To: Girard Geeter- Procurement Manager
From: Richard Dutro, CxA, BCxP, CPD, LEED BD+C - TSCx
Date of Meeting: April 7, 2021
Project/Number: Forest Park Recreation Center Pool Dehumidification
Meeting Location: Forest Park Facilities
Attendees: Attached sign in sheet.
Copies To: Rick Keeney, PE

Addendum 1

TAG FILE		AAX-S-LL-PGE1P1 1VC	
DATE	03/03/21	REV	0
DRAWN BY	f w ang	SHEET	1 OF 1
DESCRIPTION		PPK-070_120 OUTDOOR (EXHAUST+PURGE+GAS+1VC)

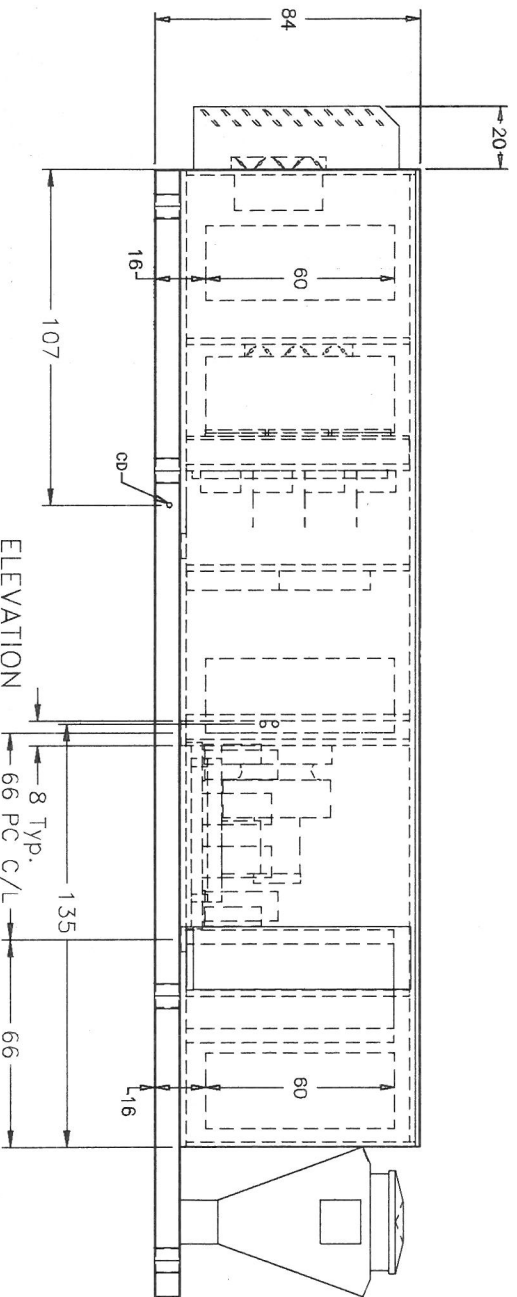
1. Contractor is responsible for the design of the concrete pad and retaining wall supporting the pool dehumidification unit. Stamped drawings not required

- a. Provide Add for stamped structural drawings
 - b. Wall to be either poured reinforced concrete or concrete block, reinforced with rebar and grout filled. Provide weep holes to relieve water pressure behind wall.

- c. Add 6' tall chain link fence with lockable 36" door around pad perimeter. Fence can be three sided and tie into building wall. Provide 36" of clearance between unit and fence for maintenance.

- d. Submit pad and retaining wall drawing and fence for approval
 - e. Maintain functionality of the irrigation piping running through pad location
2. Provide drawing detailing wall penetration including brick support for pool unit ductwork into building
